EXHIBIT B

Revision No. 1 to License Amendment Request dated June 24, 1983

Prairie Island Nuclear Generating Plant

Revision No. 1 to License Amendment Request - Dated June 24, 1983

FIGURE TS.3.10-5
REV

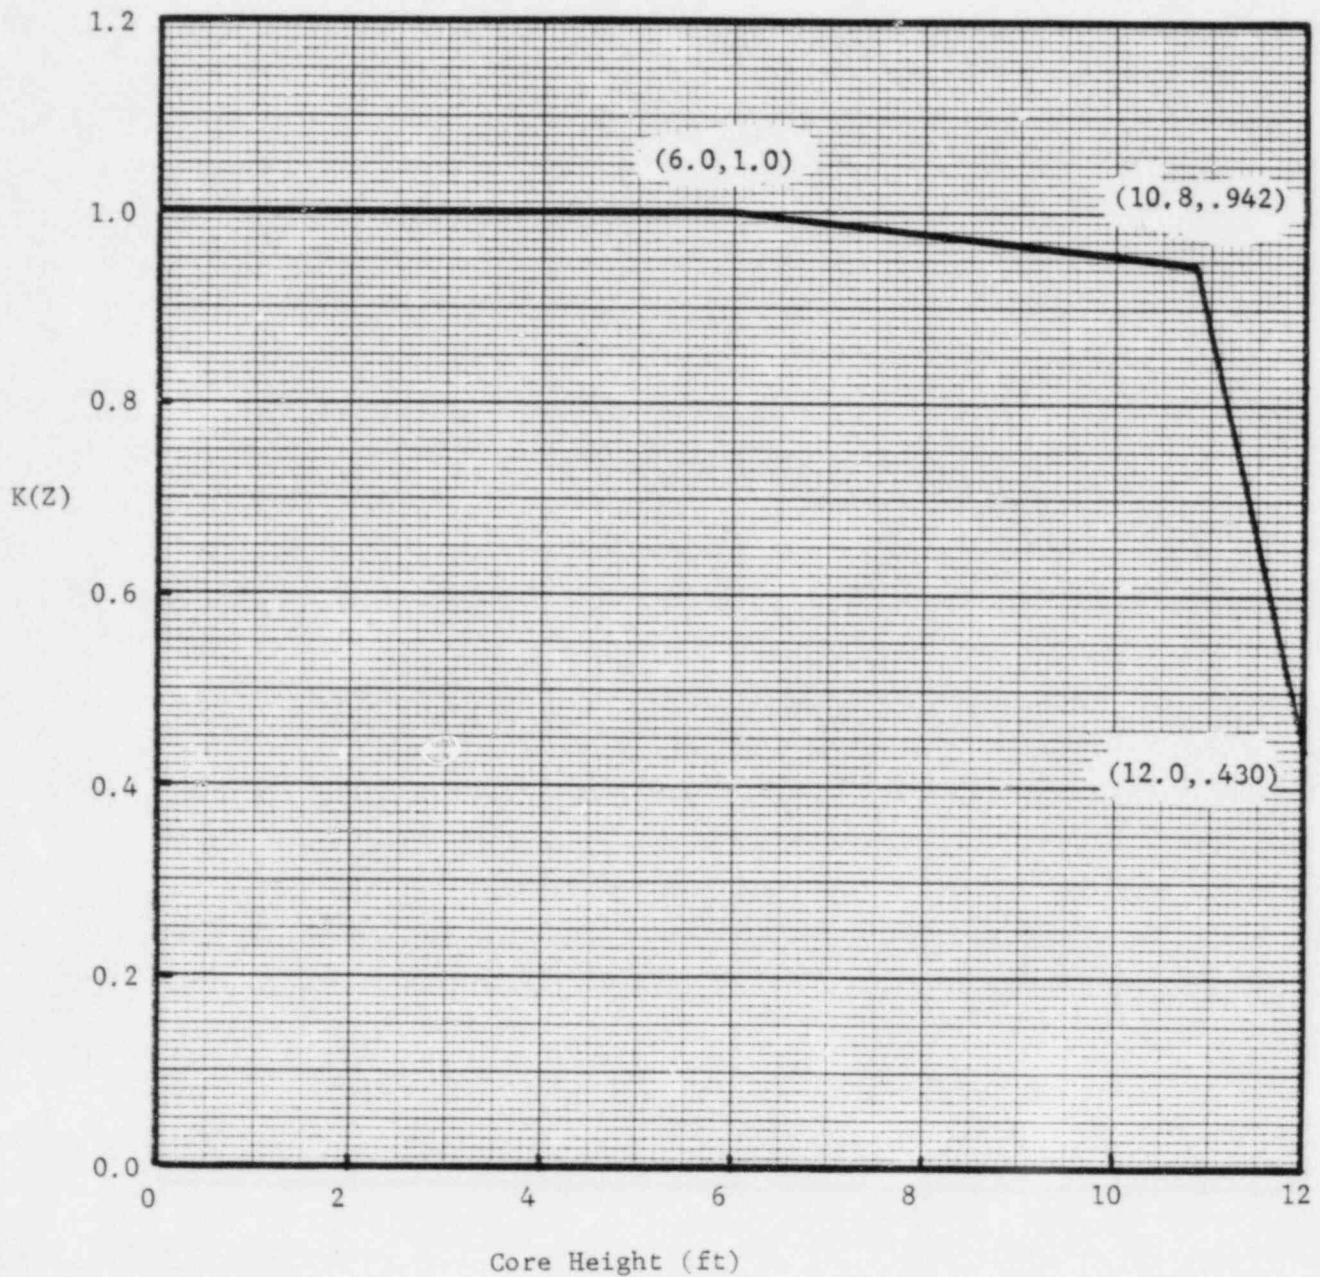
HOT CHANNEL FACTOR NORMALIZED
OPERATING ENVELOPE FOR $F_Q = 2.32$
